**RESPONSE TO ASSESSMENT MANAGER'S INFORMATION REQUEST
DEVELOPMENT ASSESSMENT RULES 2017 PART 3 S13
DEVELOPMENT APPLICATION FOR A DEVELOPMENT PERMIT FOR A
COMBINED MATERIAL CHANGE OF USE AND RECONFIGURING A LOT AT
79, 89, 91, 97 & 99 COURTNEY DRIVE, UPPER COOMERA
(LOTS 188-192 RP173728)**

On 12 July 2019 an Information Request was received from City of Gold Coast. It is noted that the Applicant's Response Period was extended to 11 December 2019. Pursuant to Section 13.2 of the *Development Assessment Rules 2017*, we provide our response to this information request below.

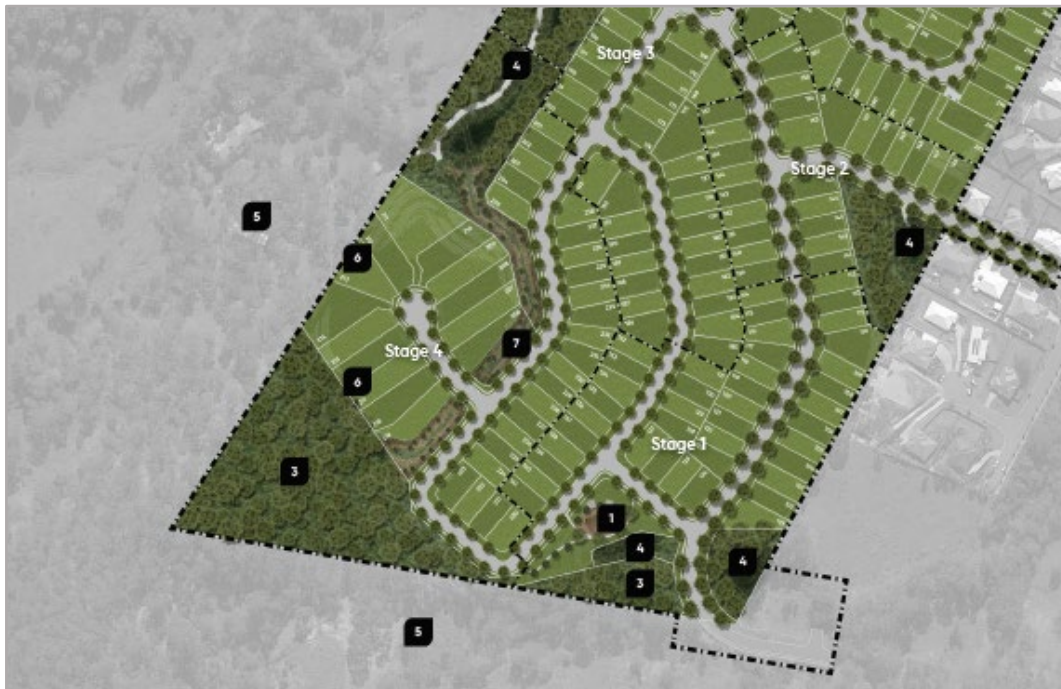
In addition to Yuan Creek, other waterways identified on the City Plan's Environmental significance – wetlands and waterways overlay map should be rehabilitated with appropriate buffers, satisfying the Environmental significance overlay code (i.e. minimum 30m buffer either side). Any buffers proposed of a lesser width should demonstrate compliance with Performance outcome 5 within an ecological assessment. These areas should be protected through either private covenant or public open space.

Please refer to the response provided in regard to Item 11 above which addresses this matter.

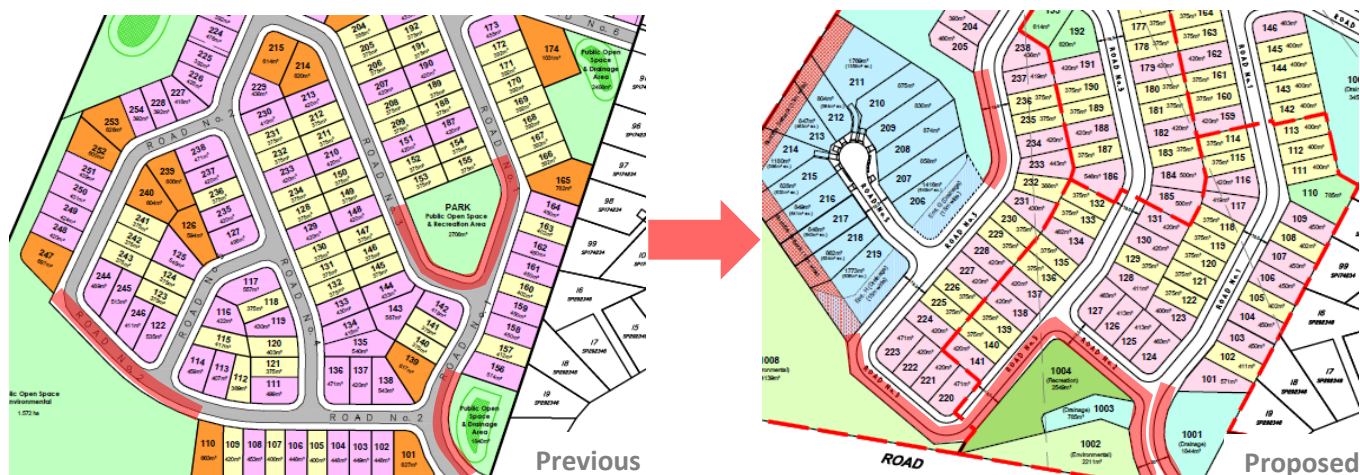
Development should maximise road frontage to public open space areas, particularly local recreation parks and waterway corridors.

The development layout has undergone an extensive review in light of the matters raised by Council in the Information Request and a revised layout is now proposed. During the review process, consideration was given to the extent of road fronting public open space areas and increased road adjoining these areas has subsequently been incorporated where possible.

All areas of public open space (e.g. recreation, drainage, environmental) have been provided with road fronting the open space with focus given to the most significant areas of open space areas being Yaun Creek corridor and recreation area in the north western area, and environmental and recreation park in the southern area. It is noted that both of these areas incorporate the development's recreation park which enjoy a minimum of two road frontages enhancing accessibility to these open space areas, creation of vistas through the development site to the open space, and ensure casual surveillance is achieved (refer below comparative images of road fronting park). Where a private allotment adjoins open space (which is not an
